RE: Draft Medium Density Design Guide and Explanation of Intended Effect for the new Medium Density Housing Code

Randwick City Council submission on *Draft Medium Density Design Guide* and *Explanation of Intended Effects: Medium Density Housing Code*

Figure 1. Dual occupancies are permitted to have individual driveway access on a 6m wide lot

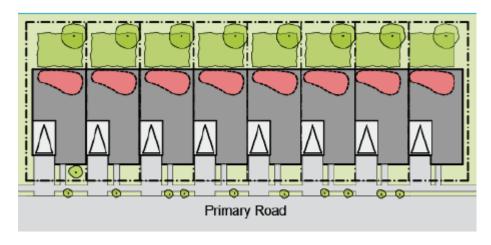
A further issue identified with regard to the permissibility requirements for complying development are the proposed minimum primary street widths, especially in relation to the cumulative impact of driveway access to primary roads for terrace-style development and other developments with narrow lot frontages. Under the proposed controls, a compliant scheme only requires a 6m lot width, which is far less than Council's current requirement of a 15m lot width for attached dual occupancies, and 18m for detached dual occupancies (which are only permissible in R3 zone). As is demonstrated in the illustrations from the MDDG below, by allowing vehicular access to a garage within the front setback of a dual occupancy or terrace, the cumulative effect has the potential of removing all on-street parking, with a minimum length of 6m required per on-street parallel parking space.

The examples illustrated are considered to be both a poor built form outcome and an unacceptable loss of amenity for residents in an LGA that already has a highly constrained parking network, and will dramatically alter the streetscape and amenity currently enjoyed in the Randwick LGA. Further, when accounting for the potential for a reduction of front setbacks than would otherwise be permissible under existing Council development controls, the impact on the streetscape and resulting amenity of adjoining properties – particularly in relation to potential view loss – could be significant. This is all the more concerning when terrace development is already currently permissible in Randwick's R3 zones, and with over half of the housing stock in Randwick consisting of medium density housing, existing development controls are both capable and demonstrated to result in better built form outcomes through a merit assessment process that allows for both an urban design appraisal of proposed development and a consideration of the cumulative impact of development in a local area.

As a worst case scenario, Council believes that it is an appropriate alternative to require mirrored pairs of driveways to provide visual relief and the return of some on-street parking should a row of terraces be constructed through the complying development process. Alternatively, allowing Council to set its own minimum lot size and frontage widths (as opposed to the imposition of a new model provision Clause 4.1B as proposed) would allow Council to retain limited control over the impact on the streetscape.
